Subject: **Docket No. 50-361**
Supplement to Response to Request for Additional Information (RAI 71)
Regarding Confirmatory Action Letter Response
(TAC No. ME 9727)
San Onofre Nuclear Generating Station, Unit 2

SOUTHERN CALIFORNIA EDISON
SUPPLEMENT TO THE RESPONSE TO REQUEST FOR ADDITIONAL
INFORMATION
REGARDING RESPONSE TO CONFIRMATORY ACTION LETTER
DOCKET NO. 50-361
TAC NO. ME 9727

Supplement to RAI 71 Response

Supplement to RAI 71 Response - Technical Basis for Median Initiation-Time Distribution Model

Figure 1 – Cumulative Distributions for Initiation Times for 3E-088 (Median vs. All Data)

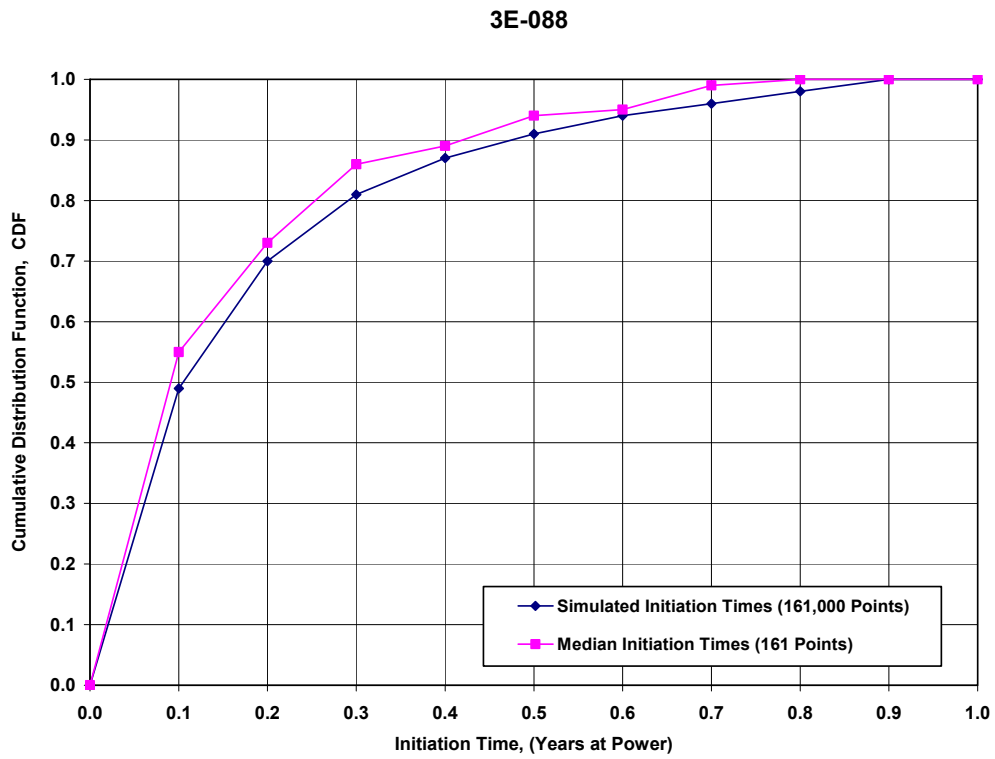
Why is it conservative to consider a median value of initiation time for each tube, rather than sampling from the distribution of initiation times developed for each tube during a given Monte Carlo trial of the tube population?

For 3E-088, there are 161 tubes that were evaluated. For a simulation involving 1000 trials per tube, the solution data set has 161,000 discrete values for t_{INIT} and corresponding wear rate for each steam generator. The corresponding distributions developed from the initiation times of all simulated values are plotted in Figure 1. The distribution for initiation times using median values for each tube (161 data points) is also plotted. This figure illustrates the global distribution of TTW initiation times for Unit 3 steam generator 3E-088. It can be seen that the two distributions for the initiation times are comparable. This is a direct consequence of the diversity in distributional form exhibited by the individual tube initiation time samples shown in Figure 2 from the RAI 71 response. Because of the diversity among the individual tubes, the cumulative distribution for median initiation times covers the full range of this key variable.

Sampling the distribution of median initiation times for each tube resulted in a conservative estimate of the Unit 3 wear depth. This is a direct consequence of the diversity in distributional form exhibited by the individual tube initiation time samples shown in Figure 2. Because of the diversity among the individual tubes, the cumulative distribution for median initiation times covers the full range of this key variable and is comparable to the distribution of individual initiation times.

Figure 4 - Discrete Wear Rates Derived from Initiation-Time Model for 3E-088

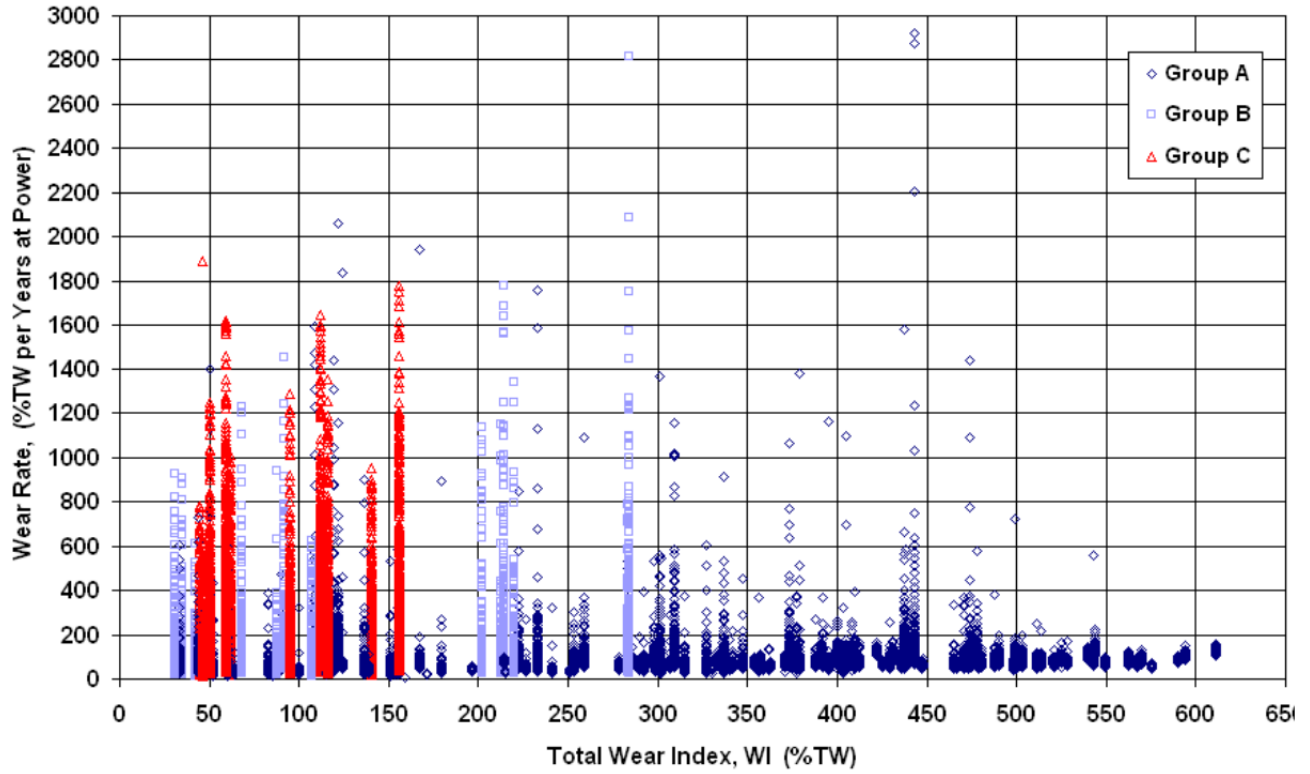
For a probabilistic assessment such as this, what is the justification for not considering a potentially large source of uncertainty associated with a key input parameter?

A plot showing the simulated TTW growth rate results for the 161 tubes is shown in Figure 4. The calculated wear rates are plotted versus the wear index for each tube. All three groups show scatter in wear rate values, which is most notable in both number and magnitude for Groups B and C. About 2% of the simulations produced wear rates exceeding 200% through wall (TW) per years at power.

The discrete data set of initiation times produces wear rate outcomes that are not realistic. These outcomes represent outliers in the initiation-time simulation process. Most of the large extreme values are the result of the few tubes at row/column locations that are at the end of column strings. These tubes were not challenging to tube integrity but produce outcomes of mathematically high wear rate values because of simulated initiation times approaching 0.926 years at power (divide by zero issue). Considering these outliers in the treatment of uncertainty and the determination of error estimates does not replicate the Unit 3 behavior.

Figure 8 - Simulated Depths for Discrete-Time and Median-Time Based Models

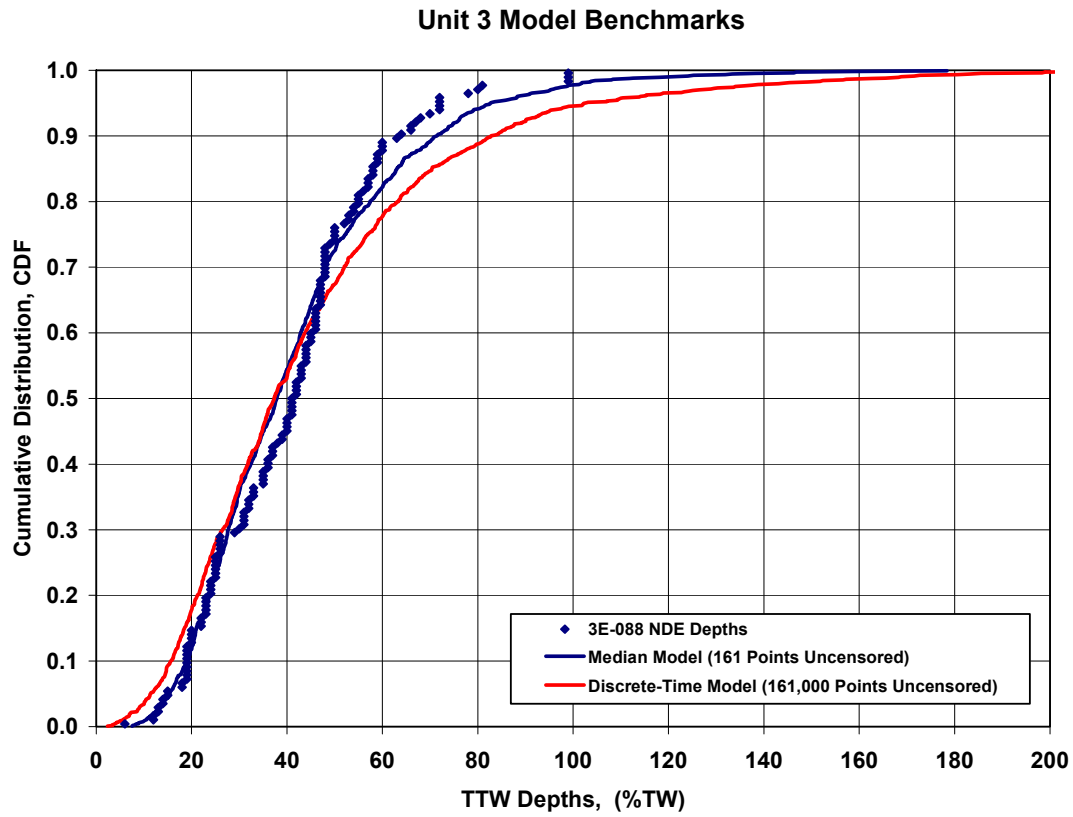
Would sampling the distribution of initiation times for each tube be a more conservative approach, as it would be expected to stretch out the tails of the resulting overall probability distribution for not meeting the 3 delta P criterion?

The results of the benchmarking process are shown in Figure 8 and Figure 9. Figure 8 shows the overall distributional comparison of the two models with the Unit 3 benchmark. Both of the models studied are conservative in the upper-tail region with regard to the Unit 3 benchmark.

Both the median and discrete time models give conservative estimates of the Unit 3 NDE depths. Use of all outcomes from the full simulation (uncensored discrete times) does produce a more conservative representation of wear rate than the median-time model. But as shown in the benchmark calculations (Figure 8), the resulting global wear rate when discrete time values are used over predicts the TTW depths observed in Unit 3 in the upper tail and in the extremes. Use of the median initiation times is conservative and gives a better benchmark with Unit 3 depths under these conditions.
